Modification or Addition to Improvement Standards and Details

Modification Number:

2010-1

3-12-2010

T - 7

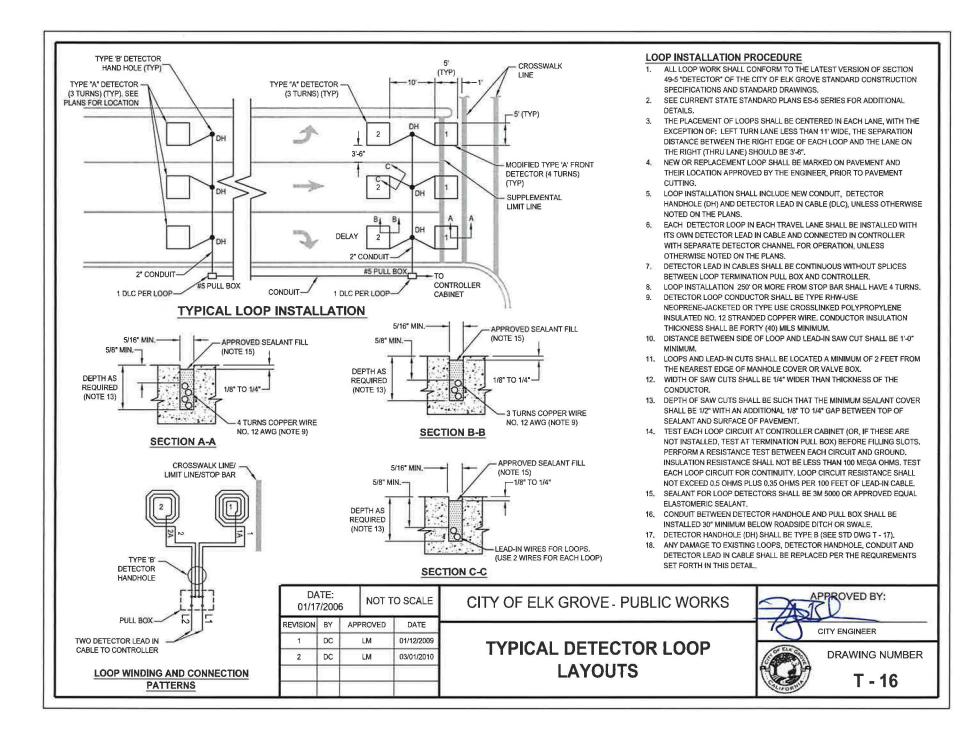
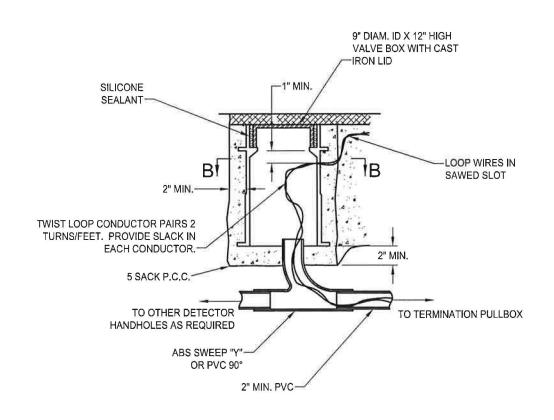
- 1. **Standard Drawing T-7**: Modify detail to eliminate the use of bike push button post adjacent to bike lane. All designated bike lanes shall be provided with bike loops.

- BIKE LOOP SHALL BE INSTALLED WITH CONDUIT, DETECTOR HANDHOLE (DH) AND DETECTOR LEAD IN CABLE (DLC) AND CONNECTED IN CONTROLLER WITH SEPARATE CHANNEL FOR OPERATION, UNLESS OTHERWISE NOTED ON THE PLANS.
- FOR BIKE LANE WITH LESS THAN 3 FEET IN WIDTH, MEASURING FROM BIKE LANE STRIPE AND LIP OF GUTTER, USE 3/4 SIZE OF BIKE LANE LEGEND.
- BIKE LANE LEGENDS, ARROWS AND BIKE DETECTOR SYMBOLS SHALL BE 2 COATS WATER BASED WHITE PAINT PER SECTION 84-3.02 OF THE STATE STANDARD SPECIFICATIONS.

ATE: 7/200	7 NOT	TO SCALE	CITY OF ELK GROVE - PUBLIC WORKS	3	PPROVED BY:
REVISION	-	APPROVED	DATE			CITY ENGINEER
1	DC	LM	03/01/2010	TYPE "B" DETECTOR HANDHOLE		DRAWING NUMBER
				DETAIL		T - 17

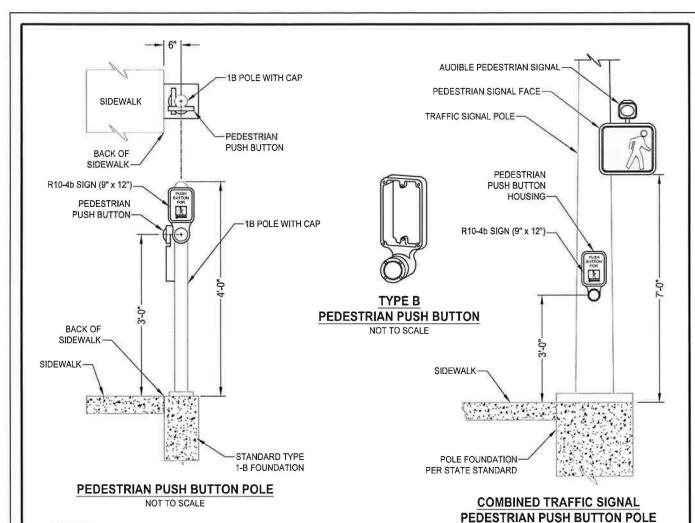
- 3. **Standard Drawing T-17**: Remove note 7 regarding the use of Type A valve box (detector handhole).
- 4. **Standard Drawing T-19**: Clarify detail and note to identify the size of the pedestrian sign R10-4B to be 9"x12". Clarify note for pedestrian push button.

- 18" SQ.± P.C.C. ENCASEMENT OUTLINE SHALL BE SAW CUT TO A MINIMUM DEPTH OF 3", EXCEPT WHERE AC OVERLAY IS TO BE PLACED.
- 2. THE PRECAST VALVE BOX WITH CAST IRON LID SHALL BE FABRICATED OF CALCIUM CARBONATE AND POLYESTER RESINS WITH FIBERGLASS REINFORCING AND DESIGNED FOR HEAVY TRAFFIC LOADS.
- CAST IRON LID SHALL BE MARKED "DETECTOR"
 AND SHALL BE SECURED IN PLACE BY APPLYING
 SILICONE SEALANT. VALVE BOX LOCATION
 SHALL BE AS SHOWN ON THE PLANS.
- 4. THE EXCAVATION AROUND THE HANDHOLE SHALL BE BACKFILLED WITH 5 SACK P.C.C.
- 5. THE HANDHOLE SHALL BE PROTECTED WITH COLD PATCH OR OTHER SUITABLE PROTECTION UNTIL PERMANENT A.C. BACKFILL IS PLACED.
- THE CEMENT USED TO JOIN THE ABS SWEEP "Y"
 TO THE PVC CONDUIT SHALL BE CAPABLE OF
 PROVIDING SOLVENT TYPE WELD BETWEEN THE
 TWO MATERIALS.
